SP-12-62-10: A site plan for the redevelopment of the Dillons store located at 1740 Massachusetts Street. Submitted by Dillons Companies, Inc, property owner of record.

ADMINISTRATIVE DETERMINATION: The Planning Director approves the above-described Site Plan subject to the following conditions:

Figure 3b. Proposed access point separation

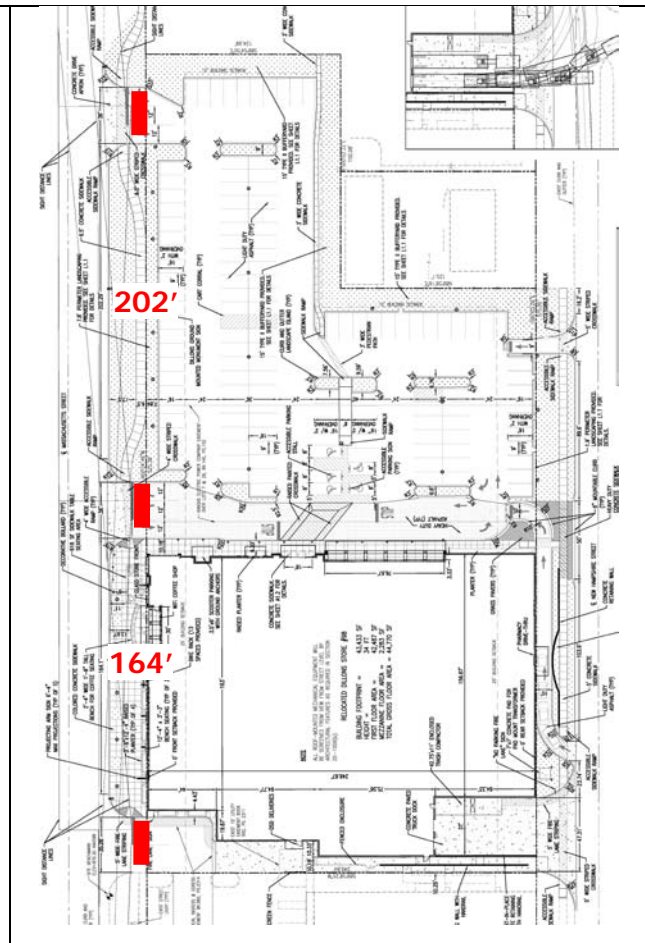
The property will have 3 access points on Massachusetts Street and 3 on New Hampshire Street. The Massachusetts Street access points include a 35.28 ft access to the loading area on the south side of the property, and 2 three-lane vehicular access points in the center and north portions of the property. The southern access point is a shared access with the property owner to the south. The spacing of the proposed access points is 164 ft between the loading access and the center access and 202 ft between the center and northern access. Currently the access points are separated by 316 ft and 100 ft. As proposed, the access points would be more evenly distributed with a spacing of 169 and 202 ft. (Figure 3) Per Section 20-915(e)(3), the City Engineer may grant a waiver from the access management standards if it is found that the requested waiver will not create a serious detriment to the safety or operation of traffic on the street and only for infill or redevelopment projects where no other option exists. The City Engineer made this determination based on a review of the Traffic Impact Study provided by the applicant. This waiver will be reported on the next Planning Commission agenda, April 25th meeting, as required by Code.

The Code allows one driveway opening with 200 ft of continuous street frontage on a local street [Section 20-915(f)]. As New Hampshire Street has more than 200 ft of continuous street

frontage, additional access points are allowed. The Fire Department indicated that the access points on Massachusetts Street are necessary to meet the Fire Code and recommended the restricted access on New to increase emergency vehicle access to the site.

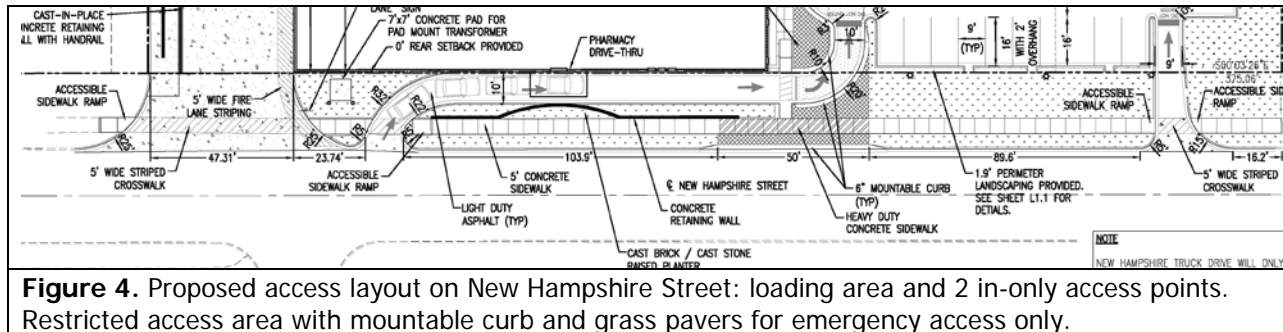
the amount of increase that is expected with the redevelopment. The Architectural Review Committee of the Historic Resources Commission (ARC) and the neighborhood both expressed concern with cut-through traffic using the direct access aisle between New Hampshire and Massachusetts Street. The applicant stated that they need direct access to accommodate semi-truck traffic in the event that access to the street network from 19th Street is ever blocked. Many in the neighborhood indicated they would prefer 'no access' onto New Hampshire Street. The applicant expressed a desire to have connectivity into the neighborhood, as well as a limited need for trucks to be able to use the access drive to access Massachusetts Street. The City Fire Inspector recommended a 20 ft wide fire access on New Hampshire Street. The access design being proposed with the revised site plan is the result of work between the fire department, city staff and the applicant. (Figure 4)

The pharmacy drive had originally been designed to both enter from and exit onto New Hampshire, but this design was revised based on safety concerns raised by the City Traffic Engineer and the neighborhood's concerns with traffic onto New Hampshire. With the proposed revision, the pharmacy drive-thru traffic is directed back into the parking lot and will then exit on Massachusetts Street. A mountable curb and grass pavers will be used to create a restricted access in the event it is needed by emergency vehicles or truck traffic if access to the south on New Hampshire Street is not possible. Members of the neighborhood association were concerned that the design of the restricted access may not be adequate to deter traffic and requested that the restricted access design be conditioned so that Dillons will change the feature if it does not function to restrict ingress and egress at that location and also if the pavers cannot support the healthy growth of grass. The grass-pavers will be located within the right-of-way and will be discussed further in the review of the use of right-of-way request.

The 'entrance-only' vehicular access point on New Hampshire is located further to the north, which removes the direct access and will help reduce the 'cut-through' traffic. When the plan was reviewed originally, the access drive was a direct line between Massachusetts and New Hampshire Streets and a raised pavement area was recommended by staff as a deterrent to cut-through traffic. With the relocation of the New Hampshire access to the north, cut-through traffic is less likely; therefore, the raised pavement is no longer required. The marked pavement is still necessary, however, to signify this as a pedestrian crossing area.

Figure 5b. Proposed cut-through route including a concrete walkway in bufferyard, crossing an access aisle and a raised walkway between parked cars to access the entry.

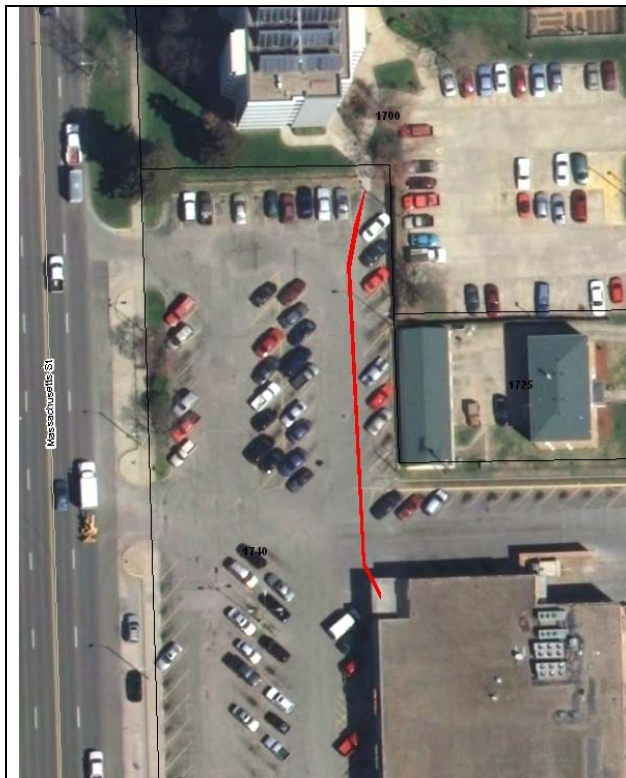
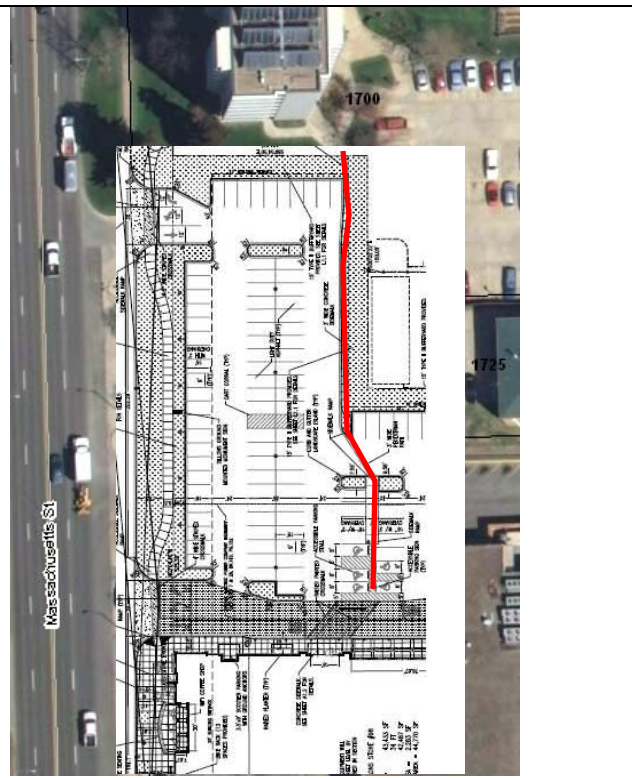
Sidewalks adjacent to the property will be installed along New Hampshire and Massachusetts Streets with this redevelopment. On Massachusetts Street, the sidewalk will meet the plaza area at the northwest corner of the store which continues to the entrances. A continuous sidewalk is also provided from New Hampshire Street to the entrance; however, it is necessary to cross the pharmacy drive-thru lane. Currently, residents from Babcock Place often cut through the parking lot to shop at Dillons. (Figure 5) A 3 ft wide walkway is proposed to connect Babcock Place with the store. This walkway will be raised where it passes between parked cars to protect the pedestrians. It would not be possible for 2 wheelchairs or walkers to pass on a 3 ft wide walkway, so the possibility of creating a wider connecting walkway was reviewed. The City Horticulture Manager recommended planting the trees farther to the east so they would not encroach into the walkway. The trees must be planted an appropriate distance from the sanitary sewer line. This would leave 4 to 5 ft of separation between the trees and the walkway. With this layout, a 5 ft sidewalk is possible.

The applicant included a pedestrian walkway within the bufferyard area and between rows of parked cars to create a safer pedestrian connection to the store than currently exists. This walkway will be widened to 5 ft to insure adequate space for the Babcock residents who may use mobility devices or shopping carts.

- ii. The 3 ft wide pedestrian walkway connecting Babcock Place to the store entrance shall be increased to 5 ft. To accommodate this, the trees in this bufferyard shall be planted further to the east, while maintaining separation, as approved by the Utilities Department, from the sanitary sewer line.
